(A) APARTMENT HOUSE ZONE
APPLICATION FOR PERMIT

Church Road, Cliff Inland.
(Mrs. Frances M. Nelson)

Subject: Building Permit to Cover Construction
of Piazza without Roof Attached to Cottage
of Mrs. Frances M. Nelson on Church Road,
Cliff Inland

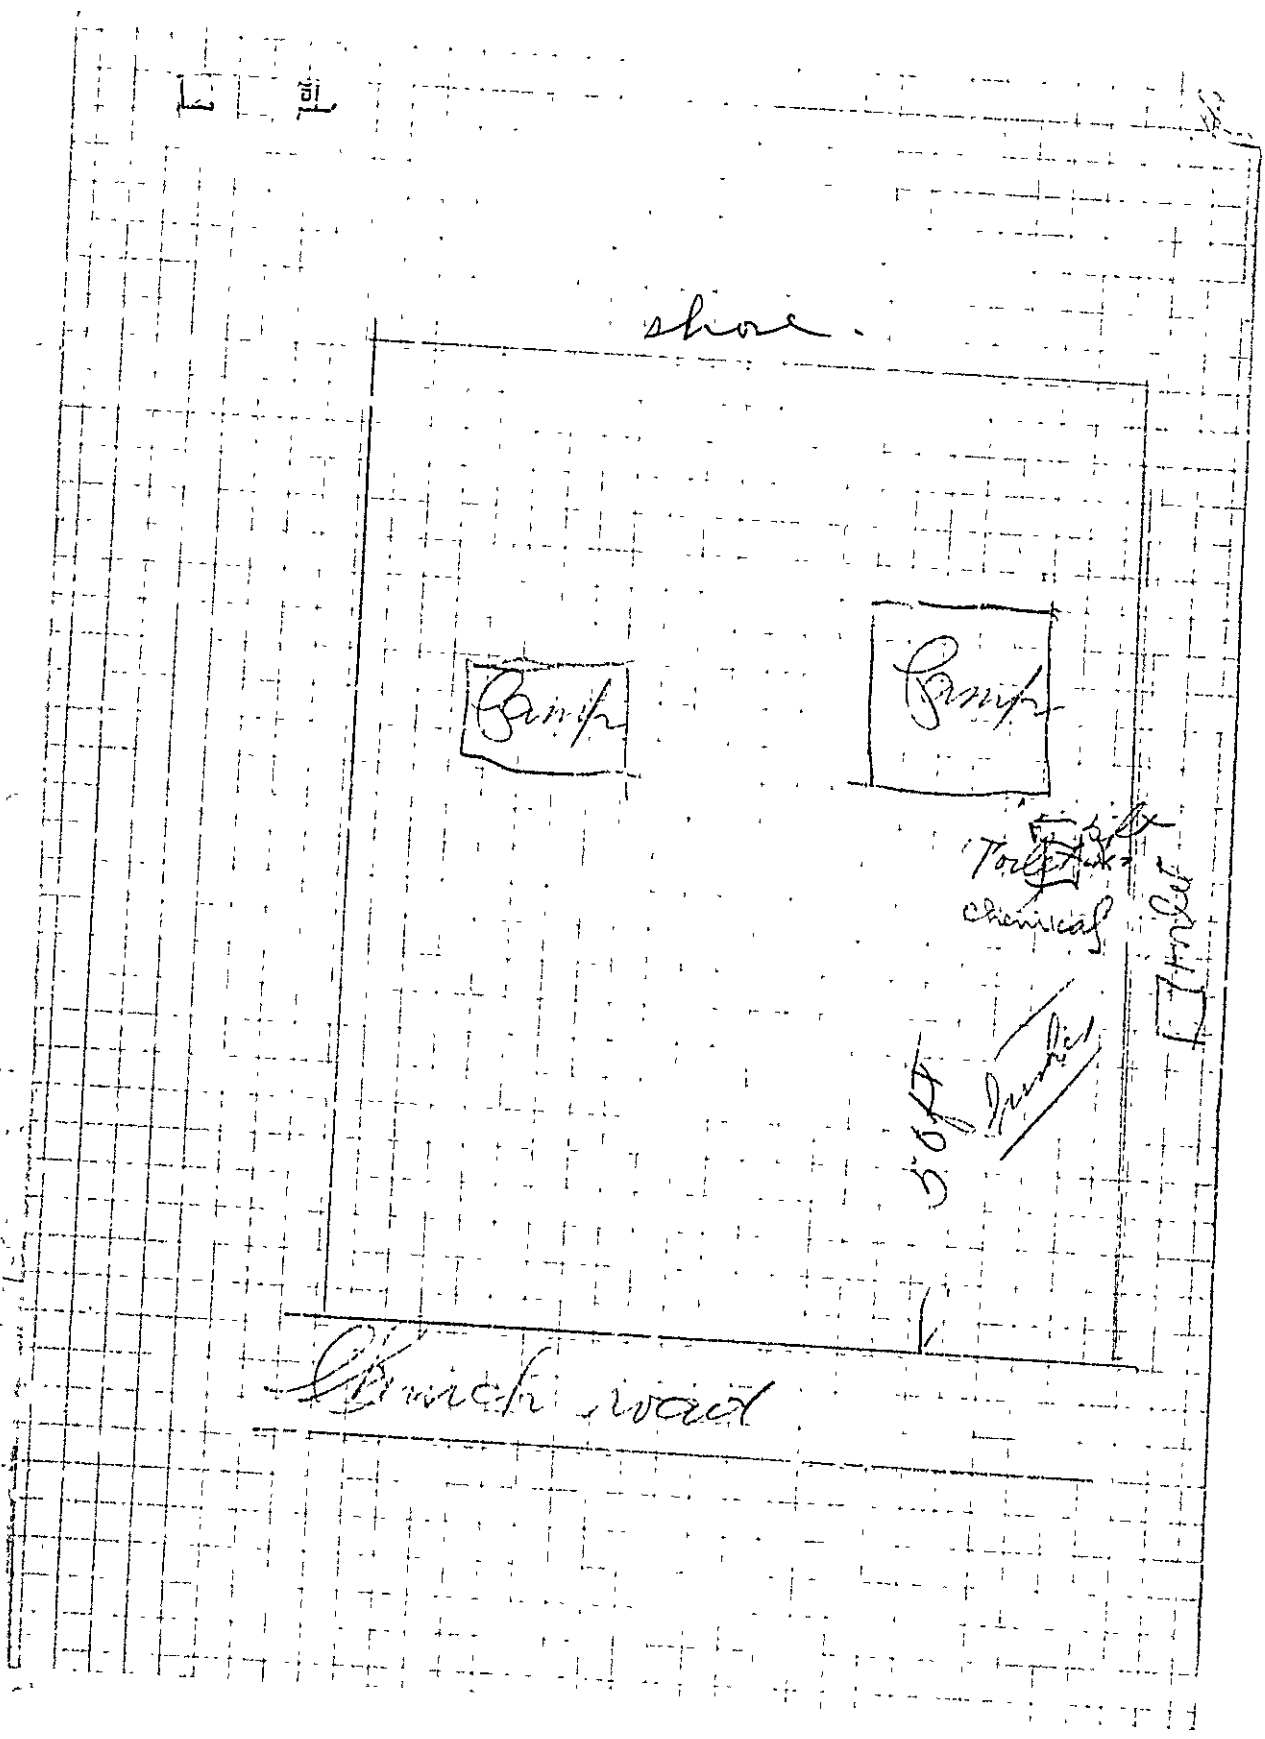
At the request of your son, the permit is issued to cover only a platform 7 feet wide and 18 feet long along the front of the cottage; and is issued subject to the following:

The 2x6 floor joists are to be spaced no more than 18 inches from center to center to comply with Building Code requirements. Instead of the 24 inches indicated on the application. Those joists are to be supported on no less than 2x3 nailing strip against the cottage, or in some equally adequate manner. They are to be supported at their outer ends either on the tops of the 4x6 sills or on no less than 2x3 nailing strips spiked to the side of the 4x6 sill and the joists notched over them.

The sills are to be 4x6's, set with the 6-inch dimension upright - all one piece of lumber in cross-section, not 2-2x6's. The sills are to be supported so that the bottom edge will be no less than 6 inches above the earth or ledge below it. You have said that the sills would be supported on ledge, and that at the Church Road end the floor would be about 4 feet above the ledge. It is not clear whether the ledge is exposed the entire length or covered with earth where it is some distance below the proposed floor level. Wherever earth covers the ledge, the supports of the sill are to be cedar posts or masonry piers - in either case getting a reasonably flat bearing on the ledge. If masonry piers they are to be no less than 8 inches square at the surface of the earth, and no less than 10 inches square at the bottom of the pier. Piers or posts to extend no less than 6 inches above surface of ground.

We are handicapped by not knowing just what the situation is, and have no desire to make things more difficult than necessary. If the ledge crops out at such a level that the sill could bear directly on it in such a way that the sill would not be in contact with the ground or so as to promote rot, that will be all right, but wherever there is earth beneath the sill the bottom of the sill is required to be at least 6 inches above it.

The sill will be supported at the outside corners and at two points, uniformly spaced, in between the corners, thus putting the sill on a 6-foot span, and providing support for the posts for roof which you say you will build some time in the future. If this arrangement does not meet the needs, some other adequate one may be used as the 4x6 sill is strong enough to support floor up to a span of 9 feet, but not to support posts for the future roof in between supports of the sill.

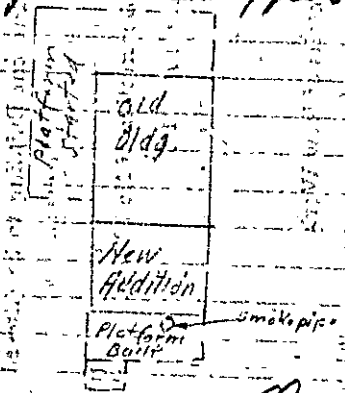
Have apparently started an open flat form on the front and side of this house, whether this is to be roofed over or not is hard to know now, have built a pear-pouch about 3x10' and looks as though this is to be roofed over.

Floor joists 2x6 on 36" centers
 good for 8.80*
 $\frac{8.80}{25} = 36$ sqft

probably o.k. but should be bridged.

Sills are 3x7 flat about 10'0" apart

$\frac{7 \times 9}{6} = 10.5 \times 1100 = 10,550$
 $\frac{8 \times 10.550}{120} = 700$ #
 Outside wall
 $7 \times 10 \times 15 = 350$ #
 Floor
 $10 \times 5 \times 20 = 1000$
 1350 #

Have a metal smoke-pipe through back wall, held in place by wood supports.

10/15/30 - Mrs. Nelson agreed to remove smoke pipe and keep it down; also to get permit before proceeding
